New England Highway bypass of Singleton

Submissions report

Transport for NSW | August 2020

FIG. 1-7 The northern connection

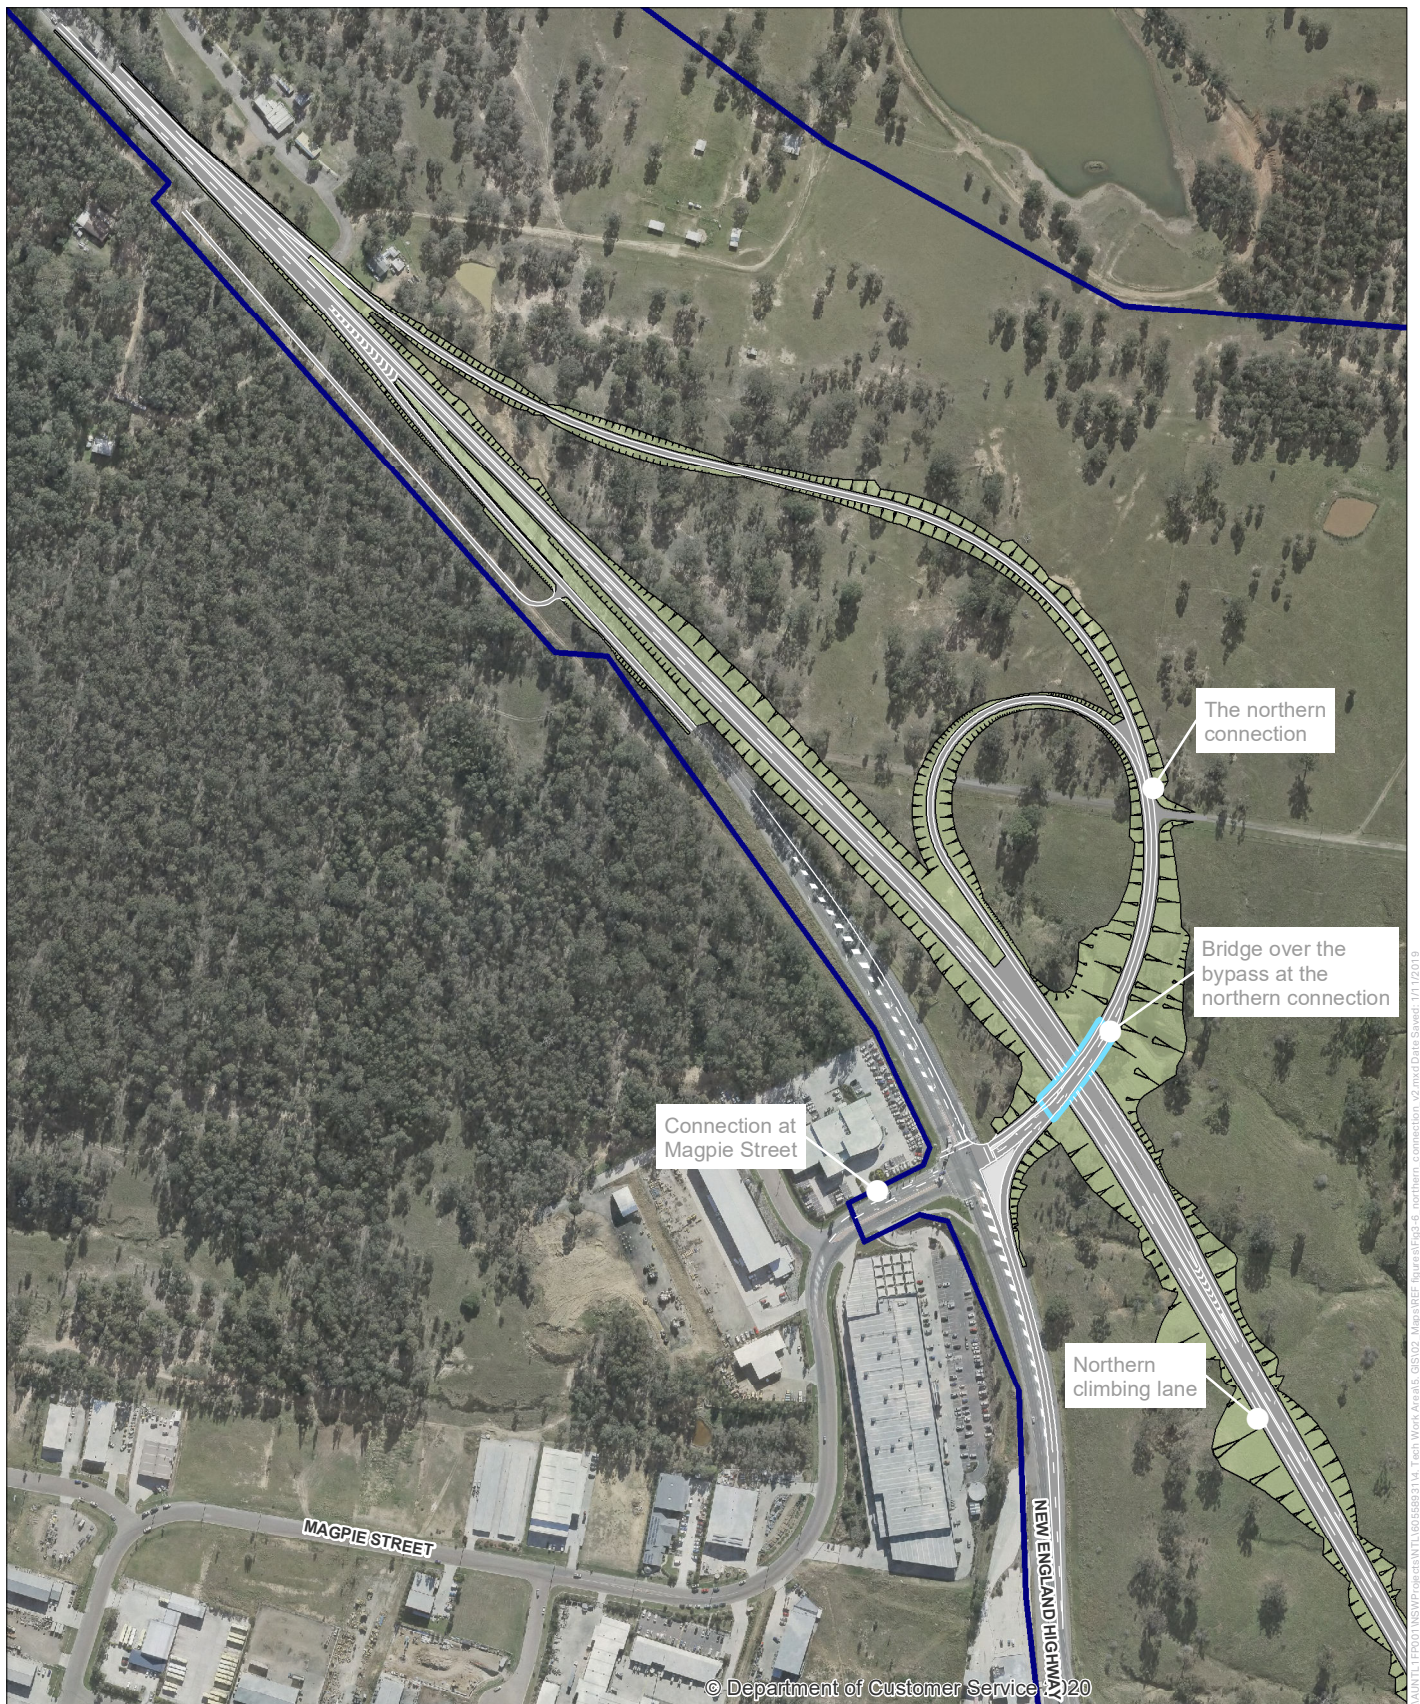
12	Northern Connection	Figure 3.6	<p>The right turn lane access to the rest area and the adjacent property are not catered for in the design. Both properties are subject to partial acquisition with restoration of full access.</p> <p>Council requests the TfNSW confirm if the right turn lane access to the rest area and</p>	The right turn access arrangement at this location would not change for the proposal.

No.	Location	Drawing/ Document No.	Issue	Response
			the adjacent property are to be catered for in the design?	
13	Northern Connection	Figure 3.6	<p>The length of the northbound merge lane, circa 220m, appears to be too short for merging to a 100km posted speed.</p> <p>Council requests that TfNSW confirms that the northbound merge lane at the northern connection meets current design guidelines for a 100km posted speed.</p>	<p>Refer to general response at the start of Section 3.2.</p> <p>The merge lane is an appropriate length.</p>
14	Northern Connection	Figure 3.6	<p>Access to the vehicle inspection area does not appear possible from the northbound lane of the bypass as it crosses the northbound merge lane from the existing NEH.</p> <p>Council requests that TfNSW clarify if the northbound merge lane at the northern connection meets current design guidelines for a 100km posted speed.</p>	The vehicle inspection area would be relocated to the southern connection.

15	The Northern Connection	Figure 3.6	<p>No provision for on-road cyclists is made for at eastern leg of intersection, allowing residents from the east cycle access to commercial area. Existing signalised intersection makes provision for north south cycle access.</p> <p>Council requests that TfNSW clarify if provision will be made for on-road cyclists is made for at eastern leg of intersection.</p>	The shoulders would be sealed and generally be three metres (or 2.5 metres on the bridge over the floodplain) which would be suitable for on-road cyclists.
